Some Comments on Annex 149B.3.2

Annex 149B.3.2

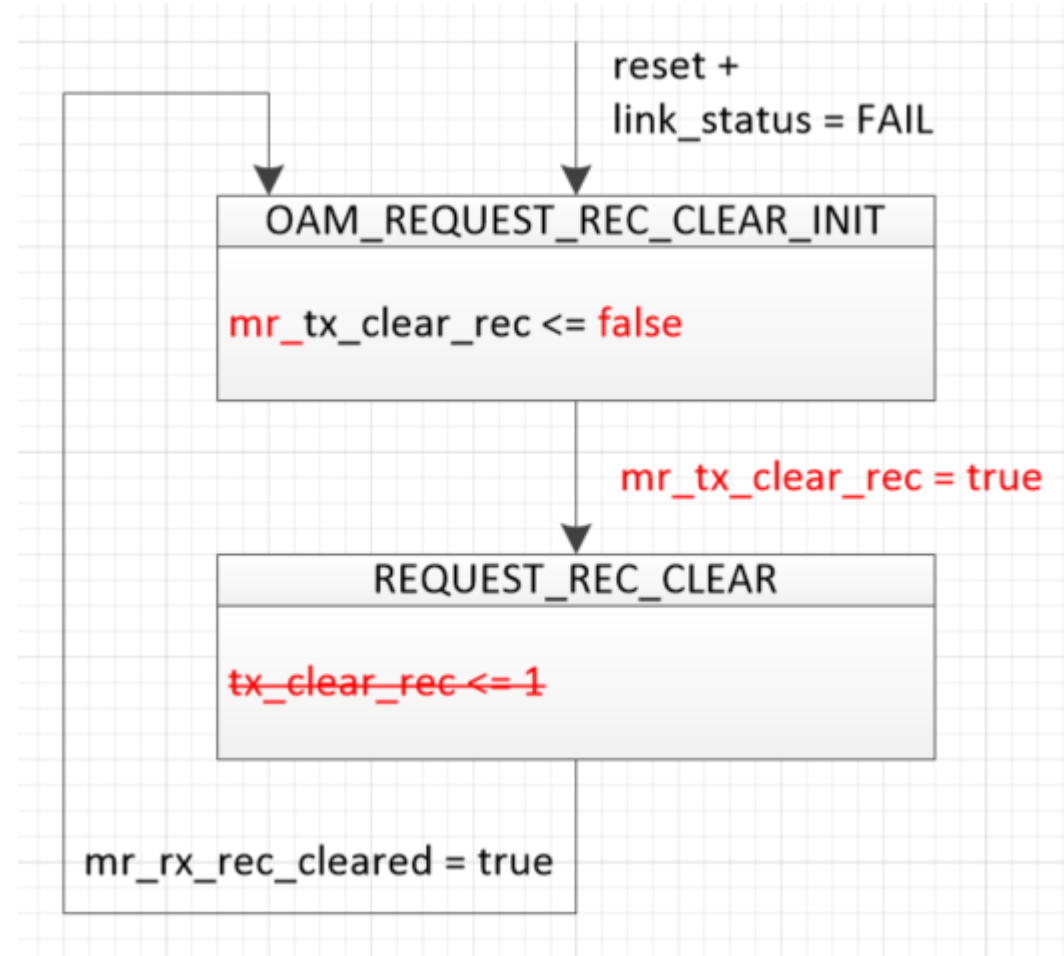
- The state diagram parameters do not seem to match well with the OAM register mapping in Table 149-9.
- I think Figure 149B-2 and Figure 149B-3 should be modified as well.
- General principle:
 - Make all variable and counter names start with mr_xxxx
 - Values of all variable should be either true or false, instead of 0 or 1
- See the proposed changes in the following slides.
